August 28, 2007

NL-07-1020

Vogtle Electric Generating Plant
Request to Change Licensed Maximum Power Level

Table 3.3.1-1 (page 5 of 9)
Reactor Trip System Instrumentation

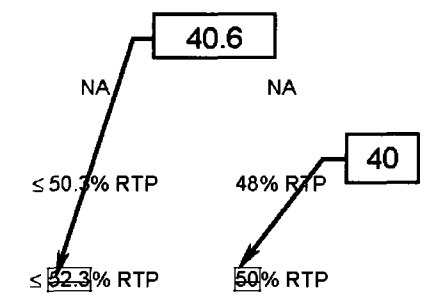
The P-9 nominal setpoint in Technical Specification Table 3.3.1-1 is being revised to 40% RTP and the Allowable Value is being revised to 40.6% RTP.
